10/13/95	ADDENDUM 1
DATE	REVISION
STATE OF HAWAII DEPARTMENT OF TRANSPORTATION HIGHWAYS DIVISION ROOF WALKWAYS COMMON WORK H-3 FINISH (UNIT III) FAIP NO. I-H3-1(75), UNIT III T.K. TUNNEL/ACCESS ROADS SCALE: 1" = 20' DATE: JUN 1995	
SHEET NO. 7A1	OF 5 SHEETS

STATE OF HAWAII
DEPARTMENT OF TRANSPORTATION
HIGHWAYS DIVISION
**ACCESS OPENING SAFETY
RAILING — HALAWA**
COMMON WORK
H-3 FINISH (UNIT III)
FAIP NO. I-H3-I(75), UNIT III
T.K. TUNNEL/ACCESS ROADS
SCALE: NONE
DATE: JUN 1995
SHEET NO. 7SI OF 6 SHEETS

POTABLE WATER TANK

FED. ROAD DIST. NO.	STATE	FED. AID PROJ. NO.	FISCAL YEAR	SHEET NO.	TOTAL SHEETS
HAWAII	HAW.	I-H3-1(75) UNIT III	1994	284	353

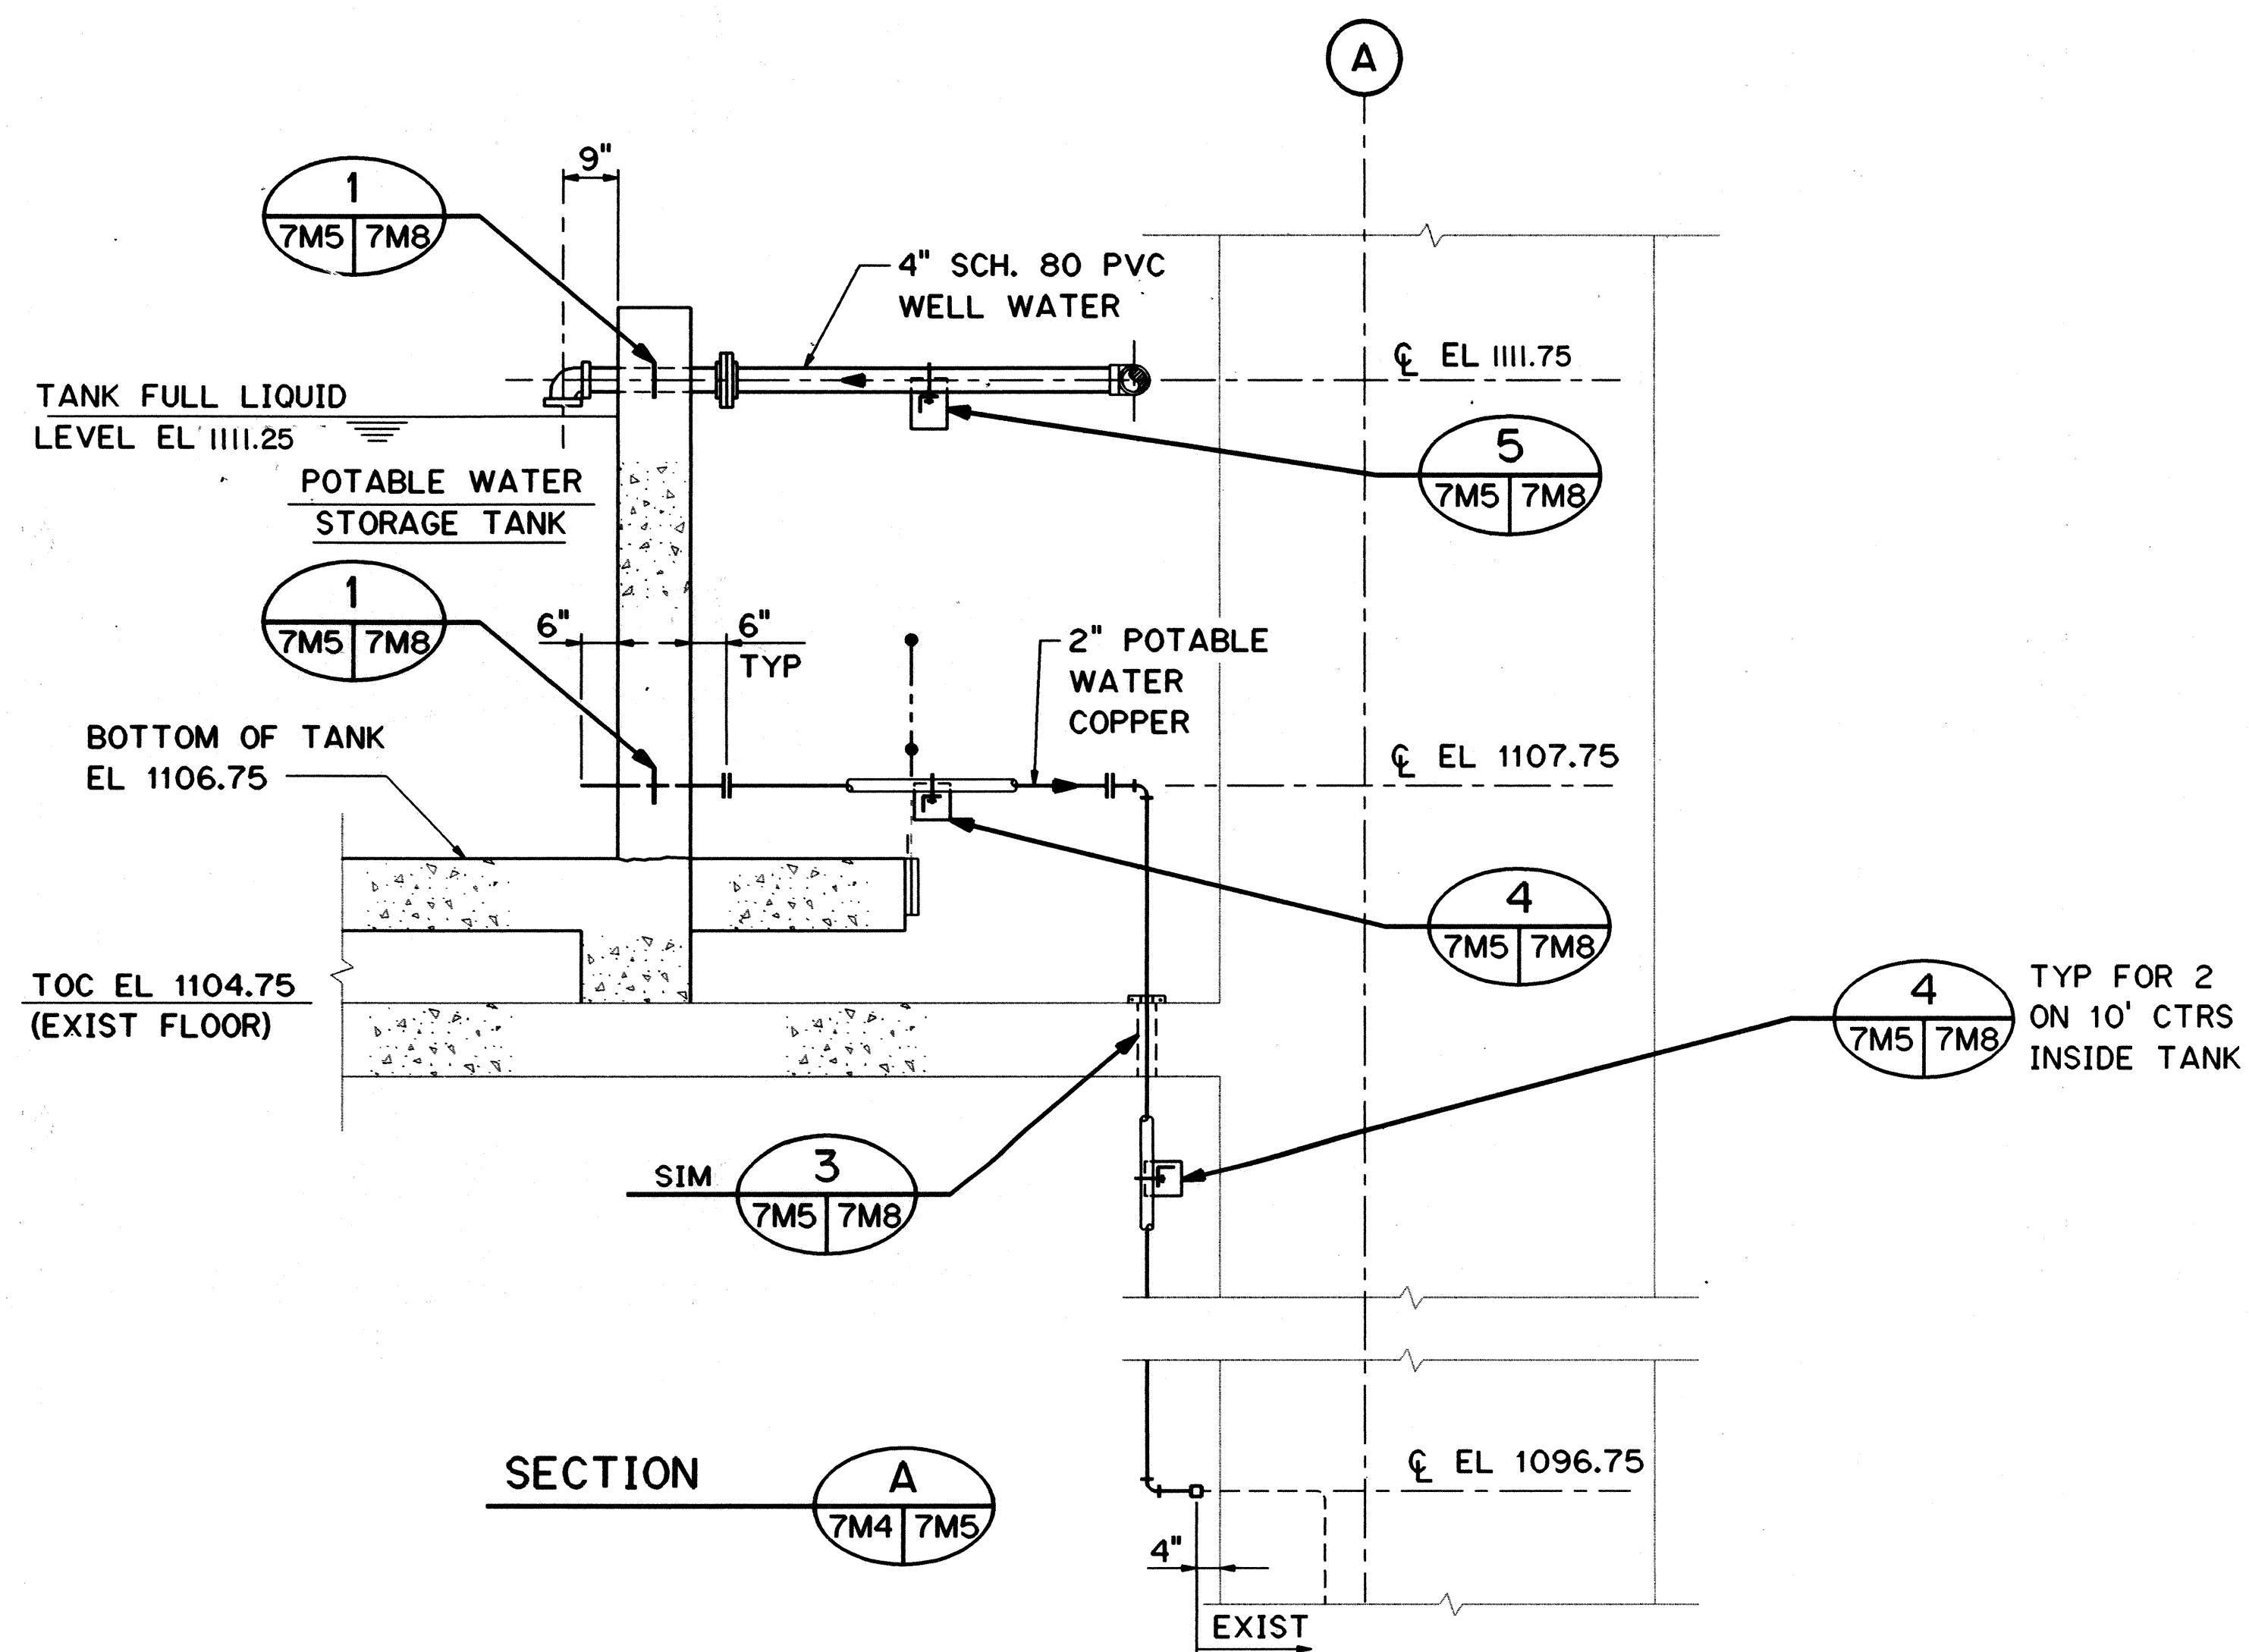
2/3/97	DCN 75-011: REVISED PIPING AND LEVEL SWITCH ELEVATIONS PER RESPONSE TO RFI # 4097-177
10/27/95	ADDENDUM 2- CHANGED PIPE SUPT. DET. 1 SIM. TO DETAIL 5 IN SECT. B
DATE	REVISION

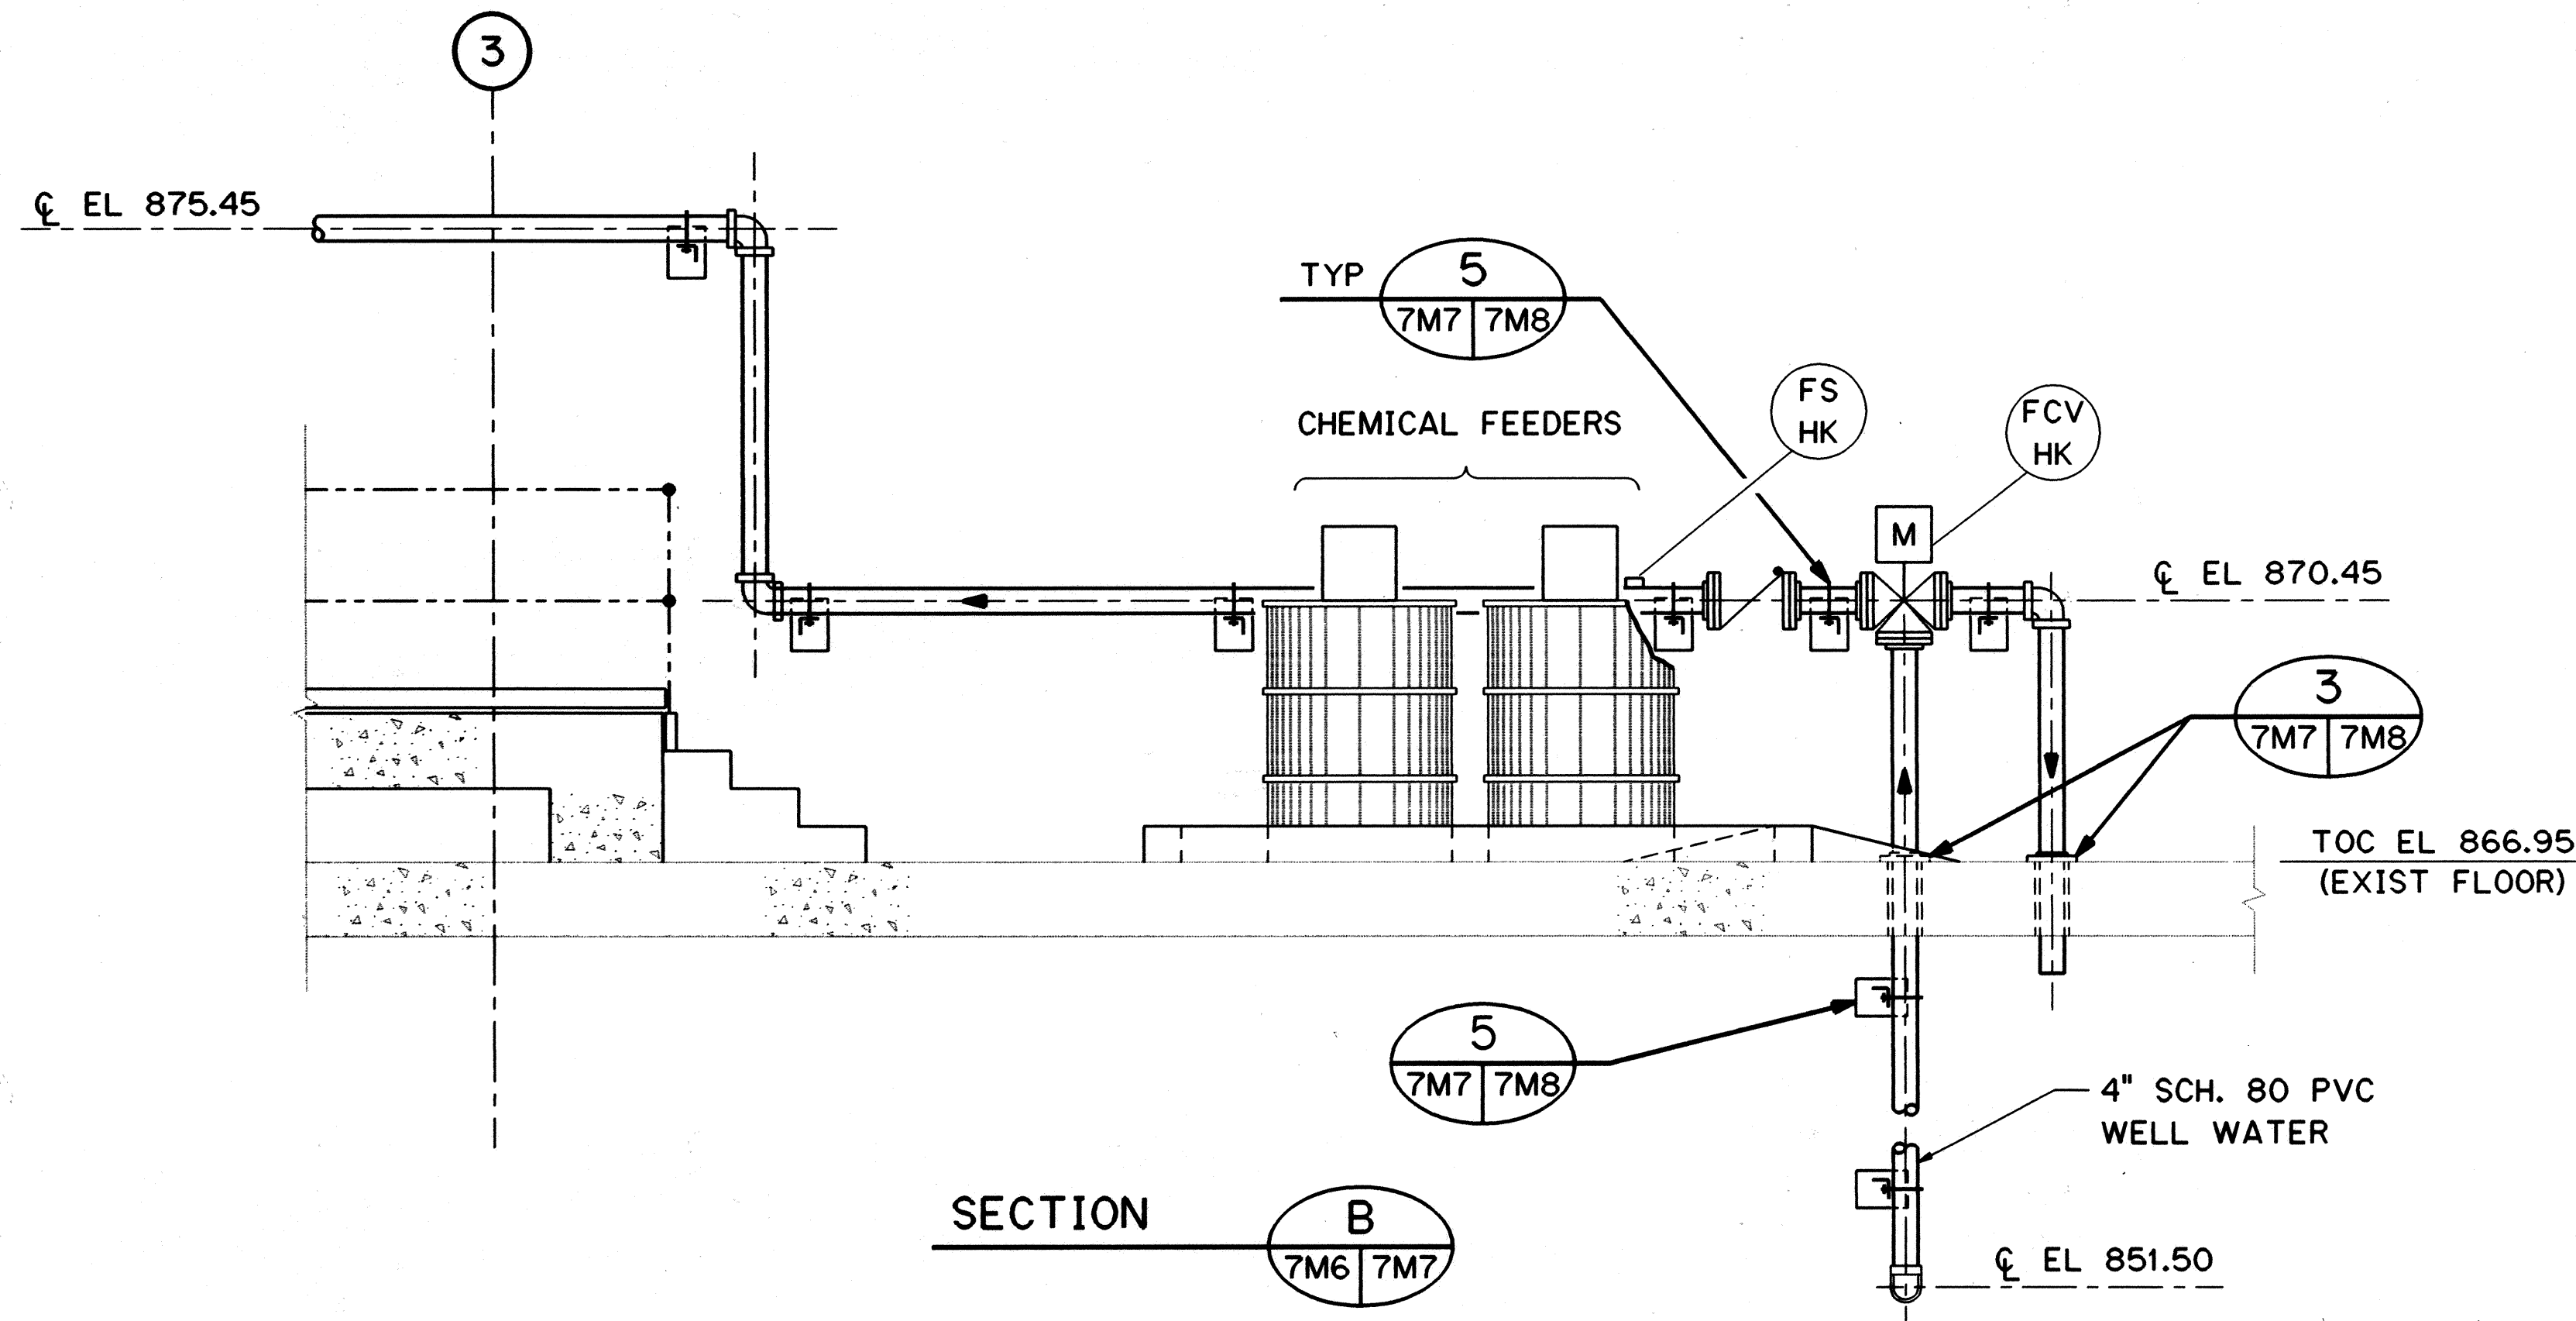
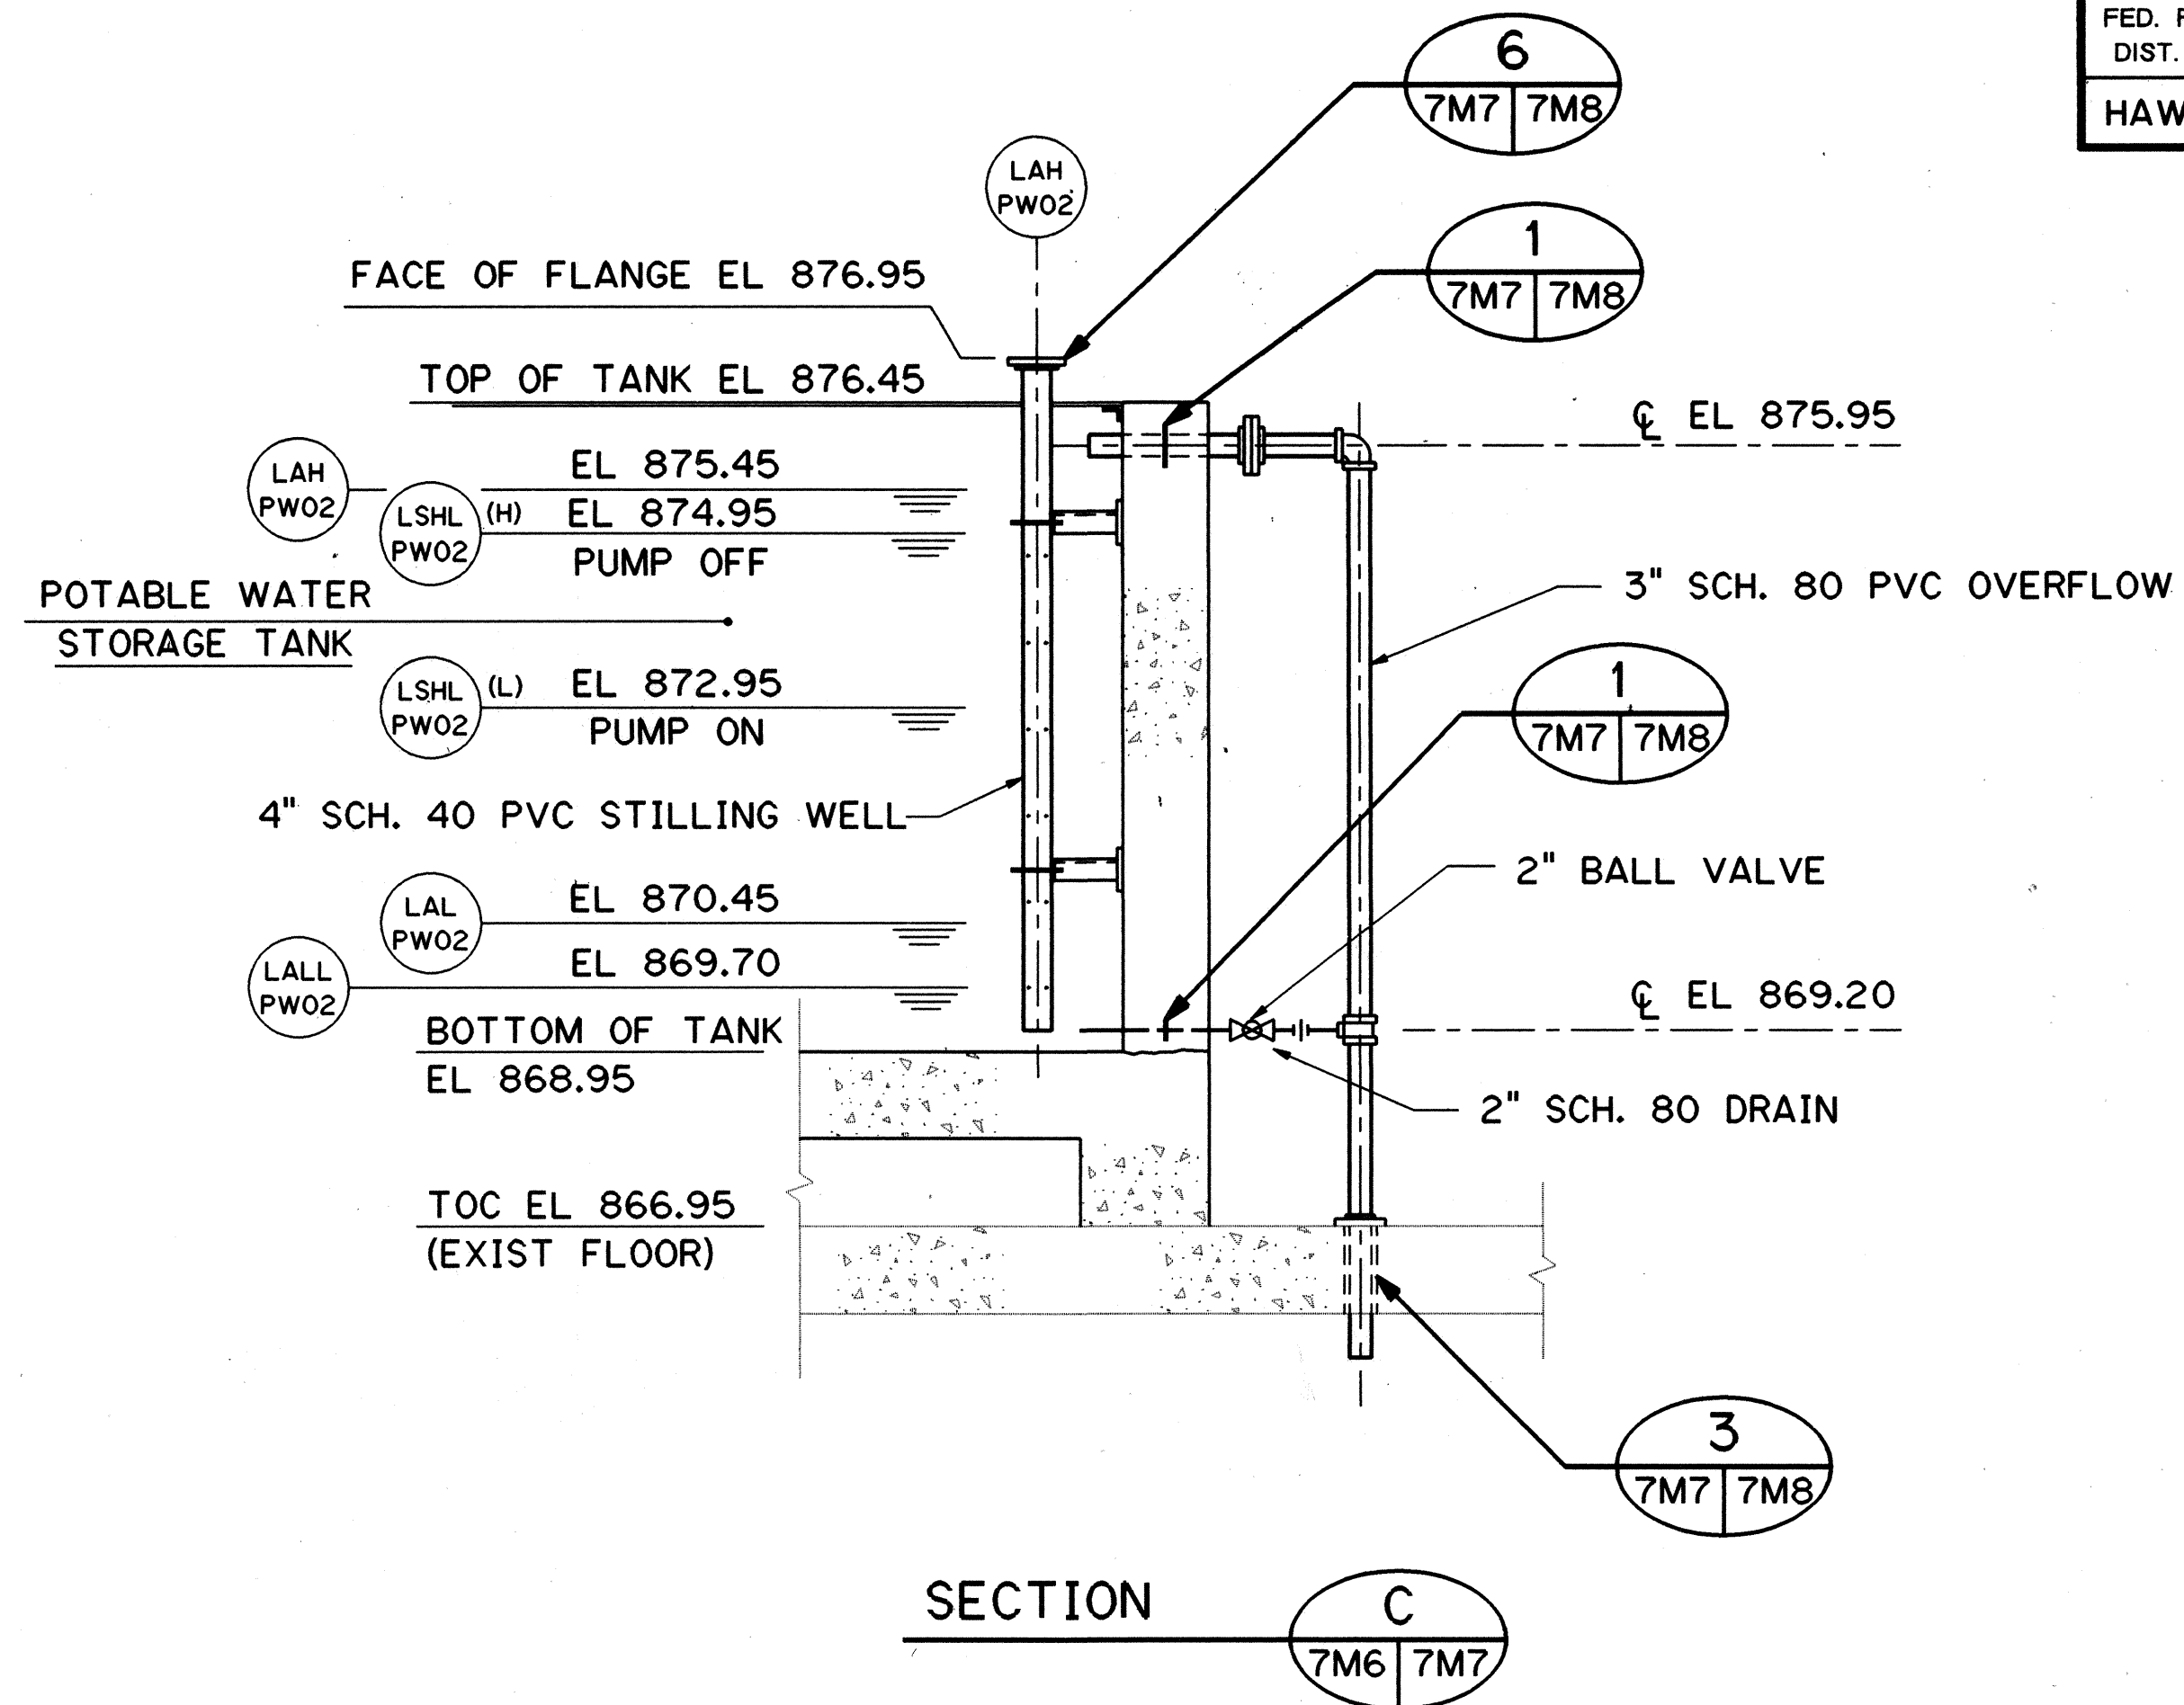
10/27/95	ADDENDUM 2-CHANGED PIPE SUPT. DETAIL 1 SIM. TO DETAIL 5 IN SECT. B
DATE	REVISION
STATE OF HAWAII DEPARTMENT OF TRANSPORTATION HIGHWAYS DIVISION HAIKU POTABLE WATER TREATMENT - SECTIONS COMMON WORK H-3 FINISH (UNIT III) FAIP NO. I-H3-1(75), UNIT III T.K. TUNNEL/ACCESS ROADS SCALE: 1/2" = 1'-0" DATE: JUN 1995	
SHEET NO. 7M7	OF 16 SHEETS
